FRESNO METROPOLITAN FLOOD CONTROL DISTRICT

April 27, 2012

- Subjects: 1) Verification of existing facilities within project limits**
- 2) Establishing District Occupancy Rights to the location**

The District has completed the review of the Contract Packages 1A, 1B and 1C provided by Tony Valdez in PDF formatting on April 18, 2012 and have the following comments to offer.

CONTRACT NO.
DRAWING NO. UT-C4028
SCALE AS SHOWN
SHEET NO.

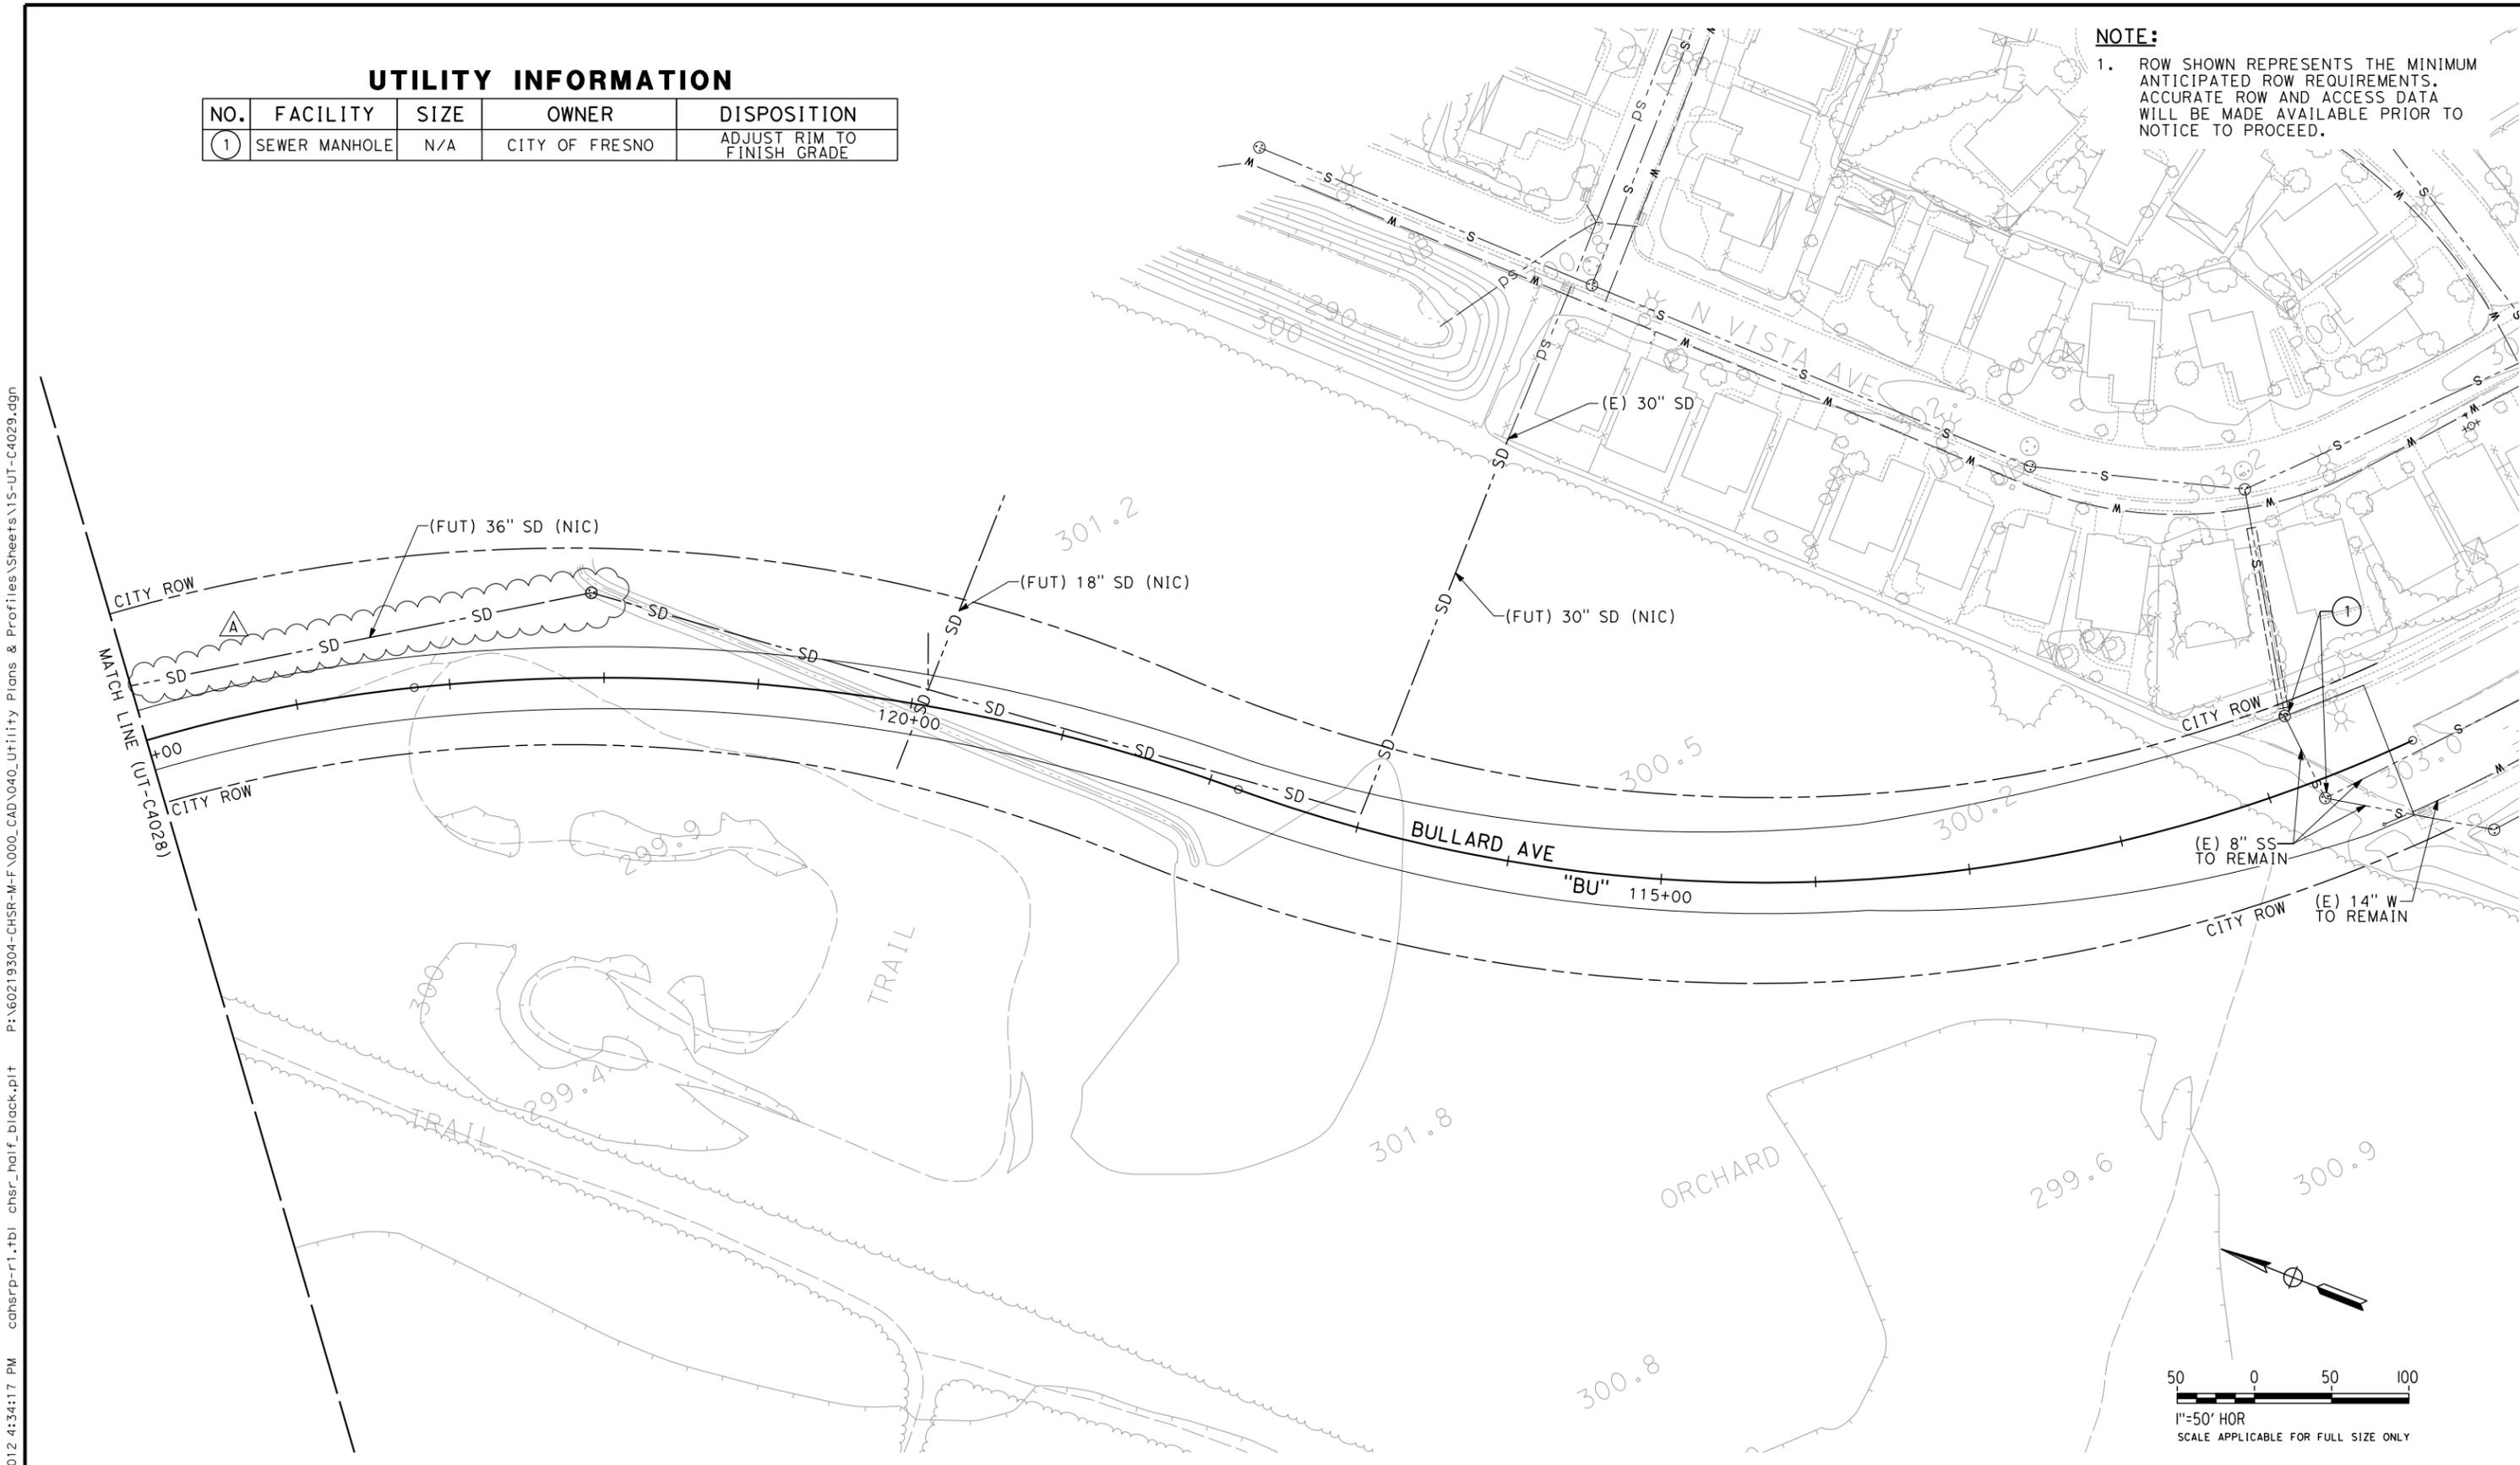
- 17) - Utilities, Composite Utility Plan, Drawing NO. UT-C4028 and C4029, the (FUT) 36-inch SD (NIC) will be located within the Bullard Avenue right of way per standards of the City of Fresno and the District, not as shown between approximately Stations 130+00 and 120+00.
